Staff Report

To: Planning and Zoning Commission
From: Erik Brubaker, Associate Planner
Report: July 9, 2025
Hearing: July 15, 2025
Item: PS25-0001: Great Northern Commerce
Applicant: Big Creek Land Company, LLC

Figure 2 - Preliminary Plat

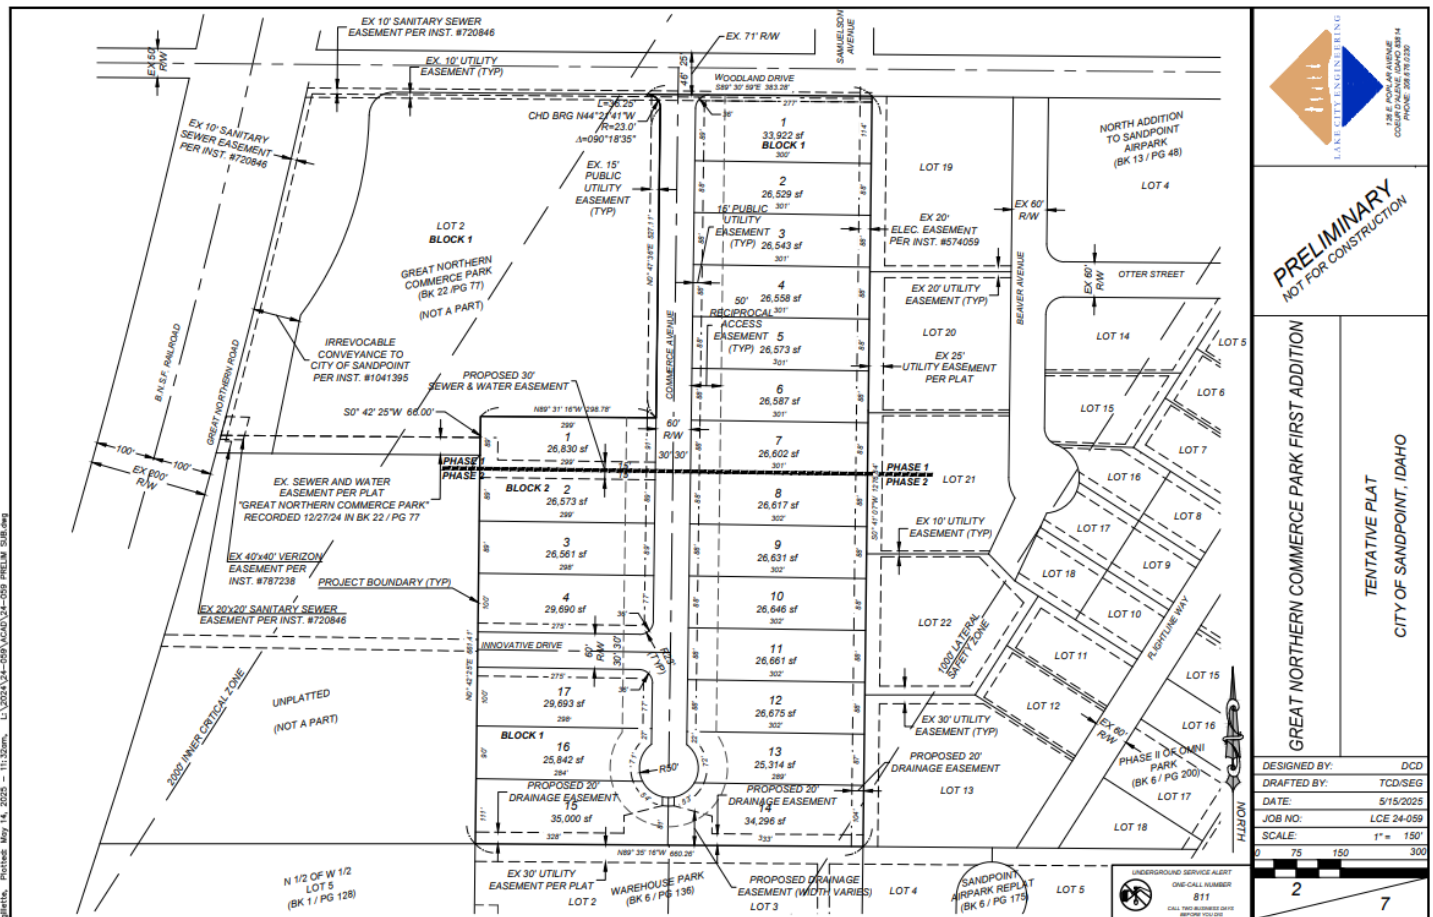
Findings: All relevant requirements of *§10-1-C* are generally present on the revised preliminary plat and/or within the application materials.

Findings: The minimum lot size in the IG zone district is one-acre, unless the parcels are within an integrated development, with recordation of cross easements to guarantee access and common maintenance of all parking and landscape areas, in which case the lots may vary from the minimum lot size and dimensions. This proposed subdivision includes access and maintenance easements for the parking and landscaped areas, satisfying the requirement. A 50'-wide Reciprocal Access and Maintenance Easement has been added as shown on the revised drawings submitted on 4/25/25. Project is compliant on the condition that the subject developer provides CCR's that address common maintenance of parking and landscaped areas prior to recording of the Plat, (See Condition 1).

Findings: The draft preliminary plat, and preliminary improvement plans generally show compliance with the required development standards. The subdivision will include a water main extension, sewer main extension, and stormwater infrastructure. The proposed right of way width of 60 feet meets city standard for a local street. Before construction of any utilities or street infrastructure within the proposed right of way, final improvement plans, stamped by a professional engineer and marked "released for construction" shall be submitted for review and approval by the City Engineer, and a separate public infrastructure permit will be required to be issued by the City Engineer.

5. Prior to approval of any Final Plat, revise plans and Plat to reflect that the streets of the North Addition to Sandpoint Airpark (to the east) are private and not Public R-O-W.
